Planning and Zoning Commission

December 03, 2019

TO: Planning and Zoning Commission
FROM: Alex Pfaltzgraff, Development Services Director
DATE: December 3, 2019
RE: Legacy Park Lot 1 – Site Plan

RE: Legacy Park Lot 1 Site Plan

OVERALL LAYOUT PLAN

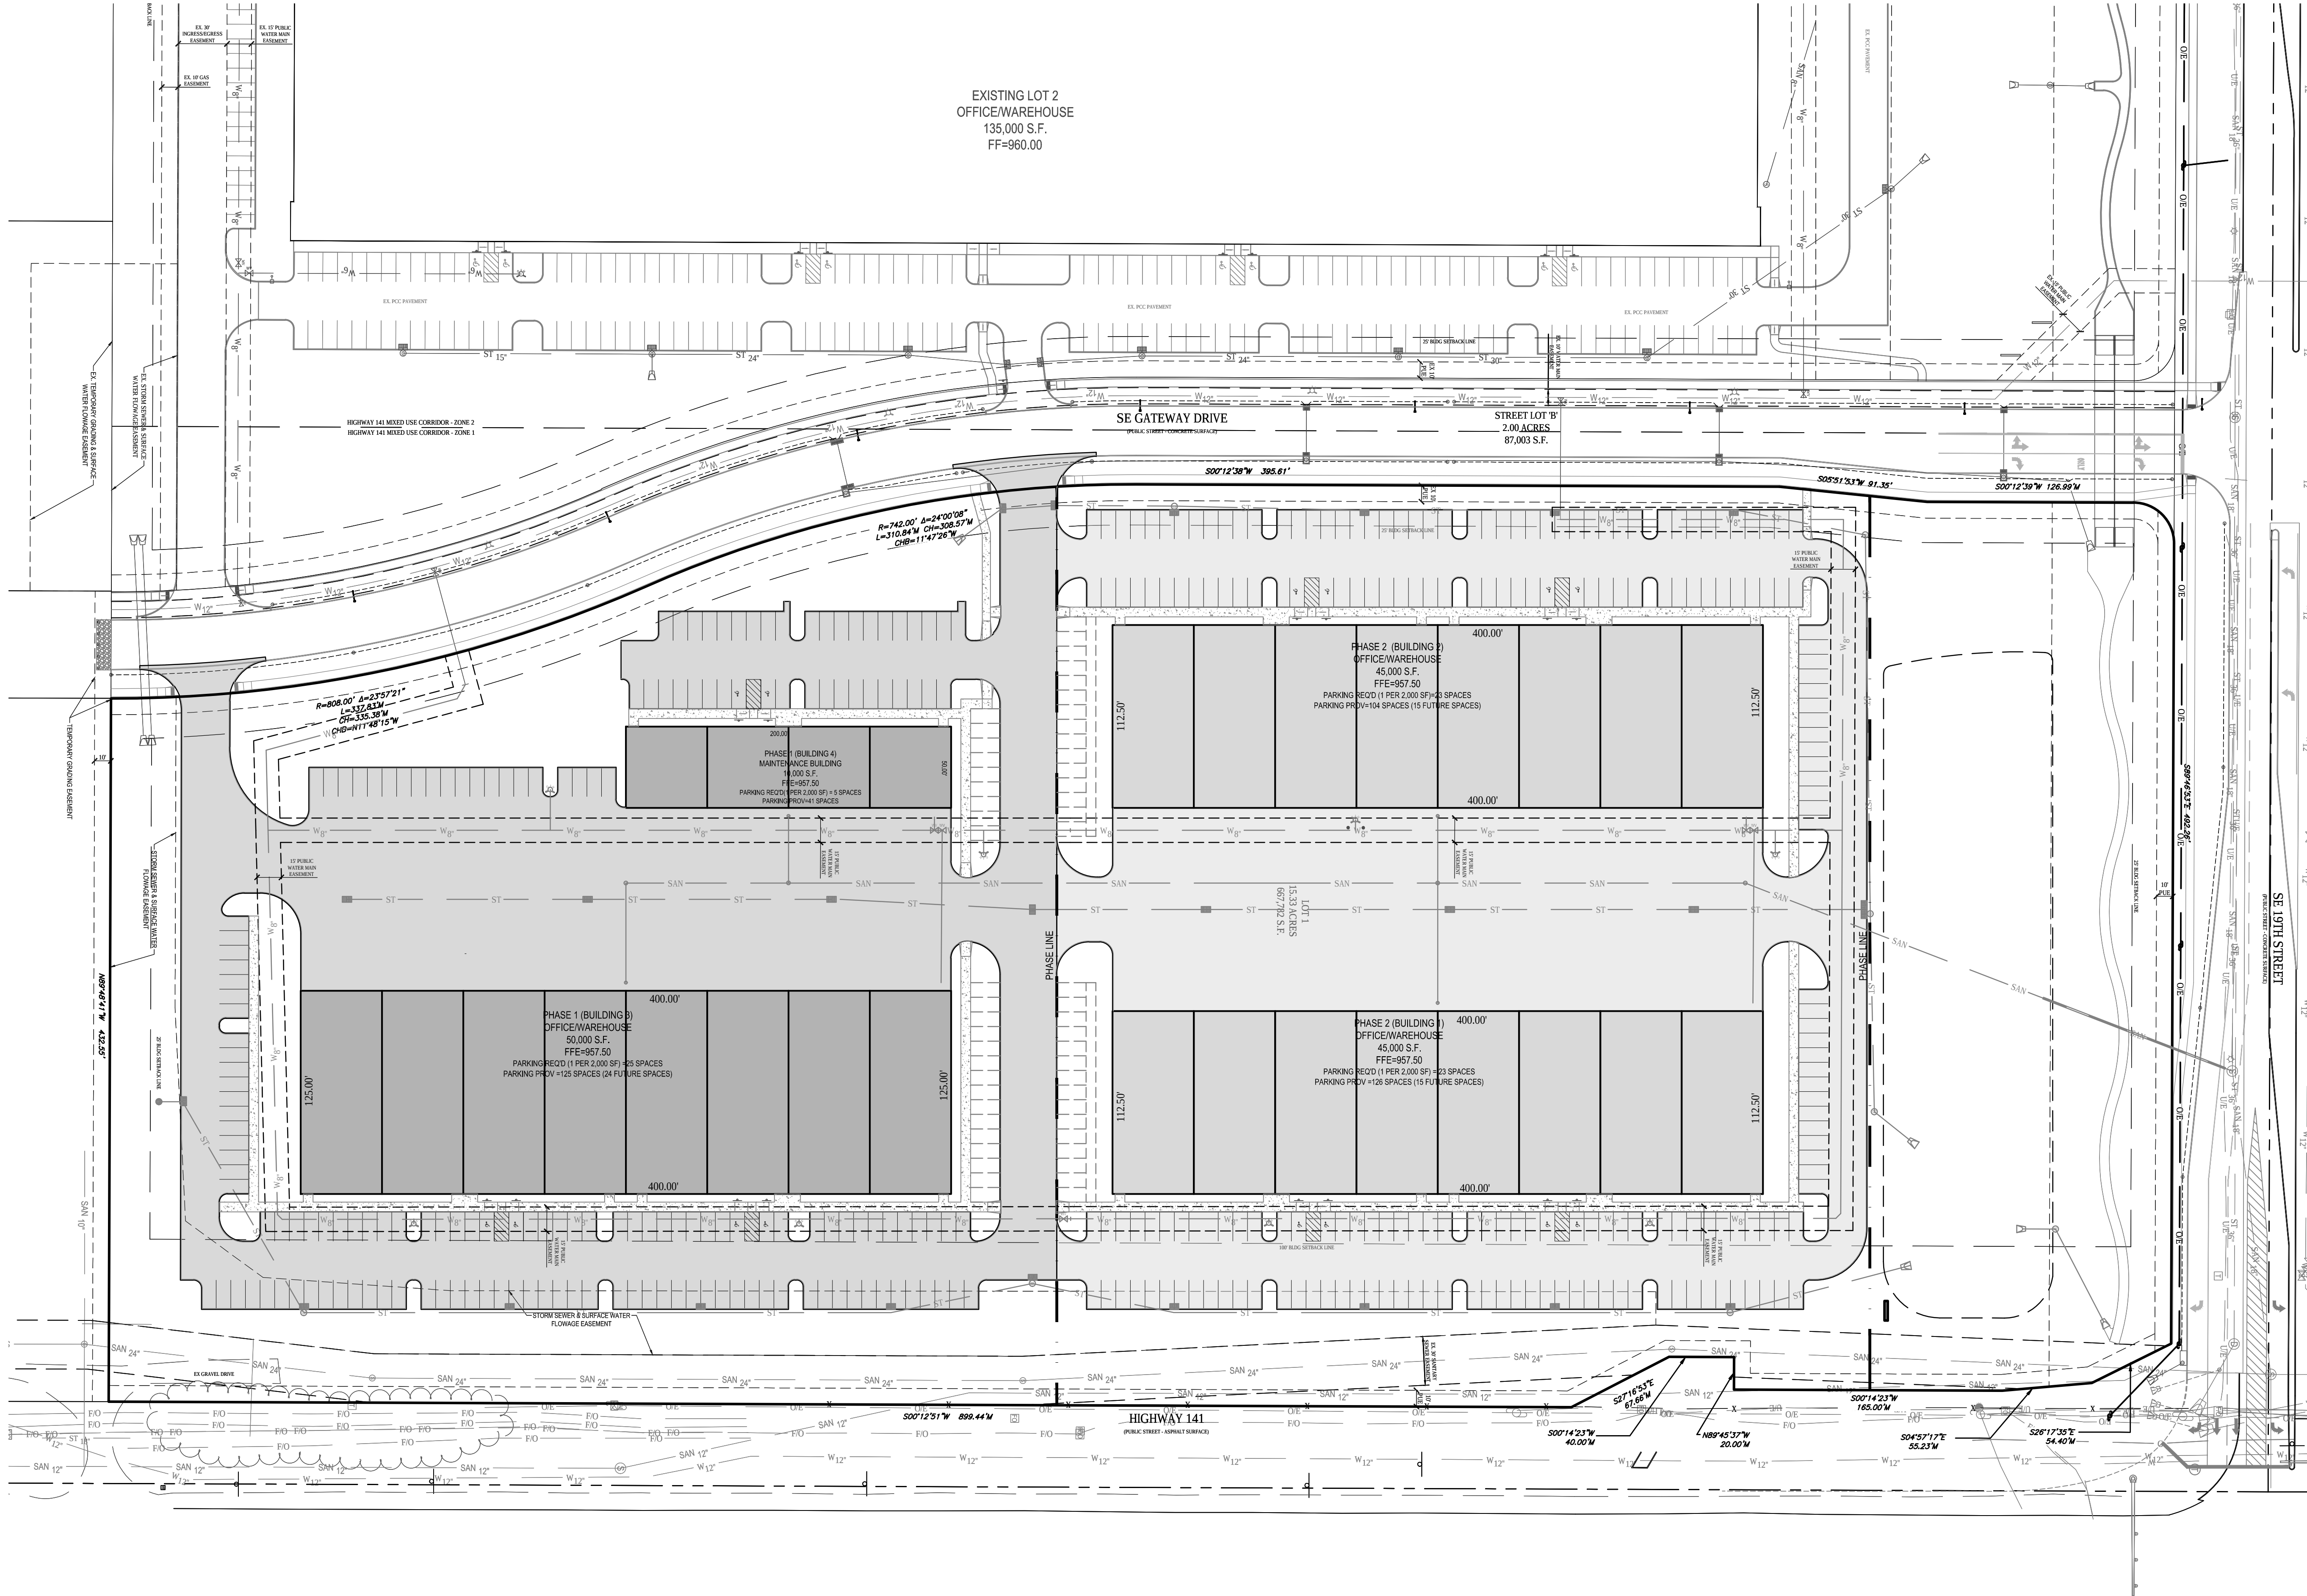
- ~~8. Please include the proposed sidewalk along SE 19th ST.~~
- ~~9. Staff questions if the linework coming across SE Gateway is existing water service lines. If they are not needed (see fire comments on hydrant layout), please note that the service lines need to be removed to the main, and the main repaired.~~

- ~~10. The phase 2, east building appears to have the incorrect square footage. Please review and revise.~~
- ~~11. Please extend the sidewalk north of the buildings in Phase 2, across the common driveway.~~

- ~~12. Please provide a corresponding ramp across from the ramp to the south of phase 2, into phase 1 (west side of site along central drive between two phases)~~

- ~~13. Please extend the sidewalk along the south side of Phase 1 across the common drive and out to the public ROW along SE Gateway.~~
- ~~14. Please add corresponding ramps for the sidewalk between the central drive along the east side of Phase 1.~~

- ~~15. Please add a pedestrian connection from the SE Gateway public ROW to the west phase 2 building.~~
- ~~16. Staff questions how garbage/recycling is handled on site. If dumpster enclosures are proposed, please provide locations and details.~~

SHEET NUMBER:
C3.1

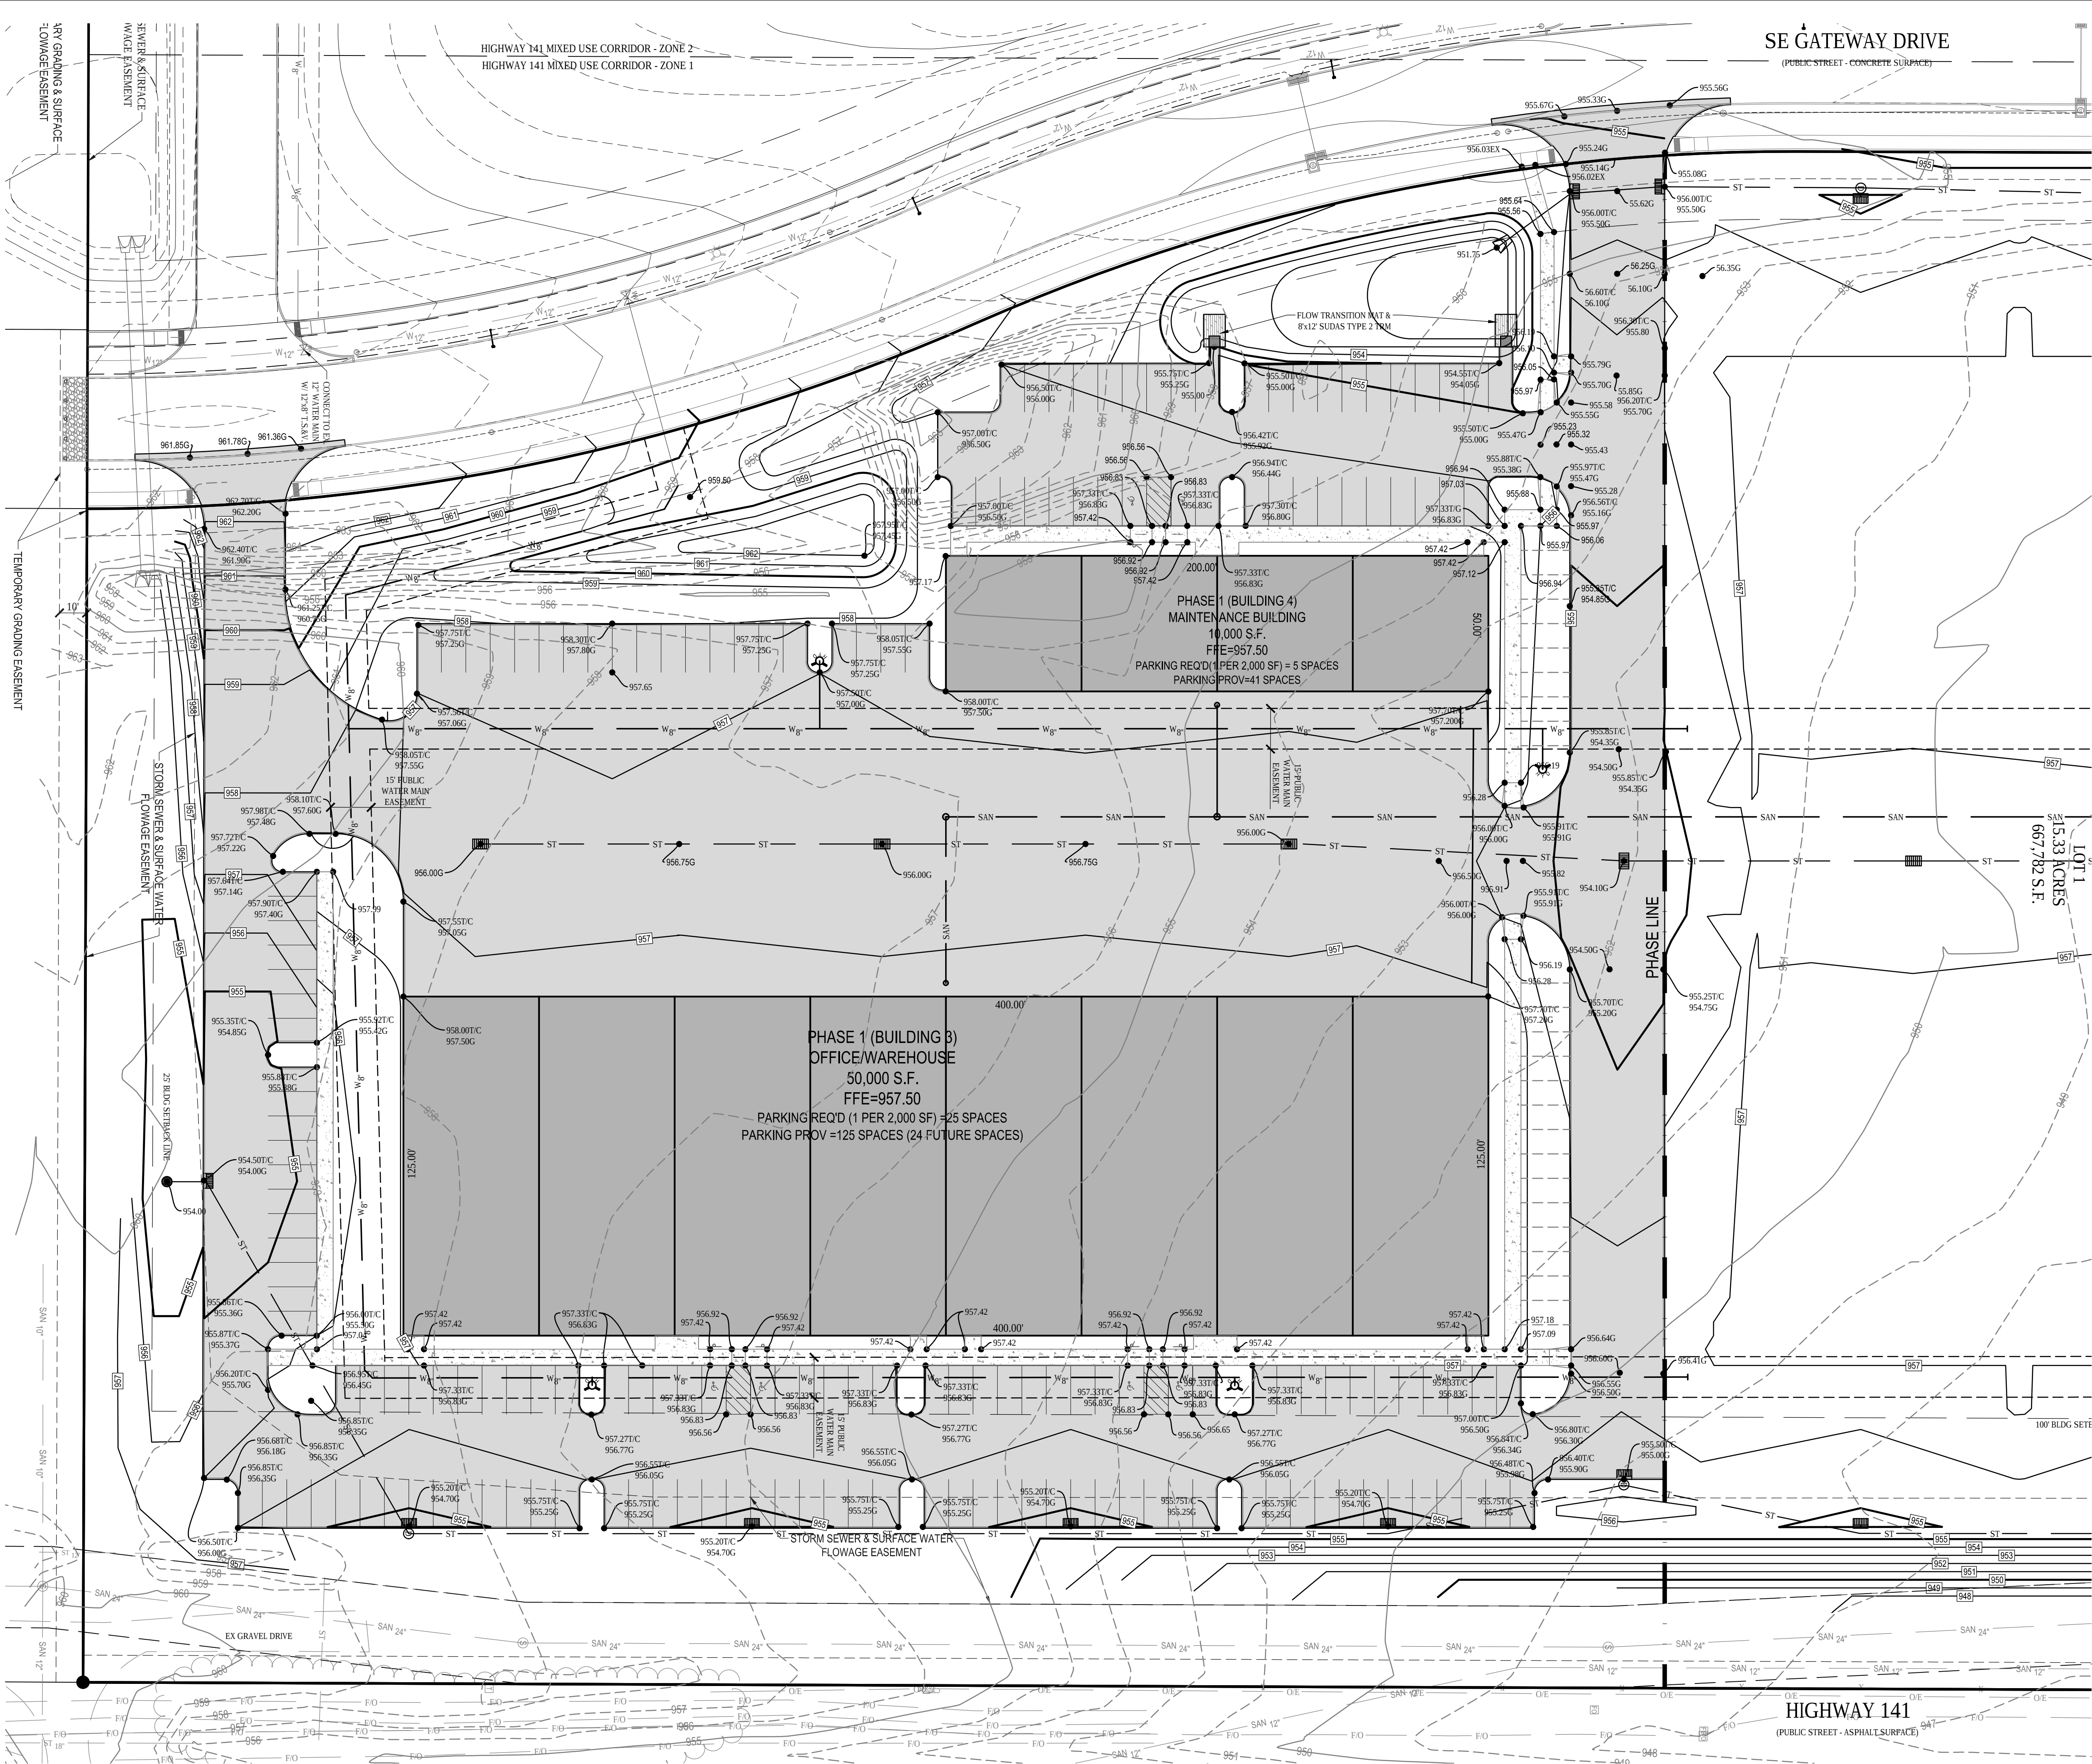
21. Please provide an enlarged detail for each sidewalk ramp and accessible stall ramp. Please identify the proposed slope of the ramp areas. **Please provide prior to P&Z**

- ~~22. The original contours appear to be wrong. Please provide prior to P&Z~~

- 23. Staff questions if there should be an emergency overflow spillway for the south detention basin. Staff does not see the spillway elevation and treatment called out.**

- ~~24. Staff questions if existing sanitary manholes between parking lot and Hwy 141 will need to be adjusted due to grade change.~~
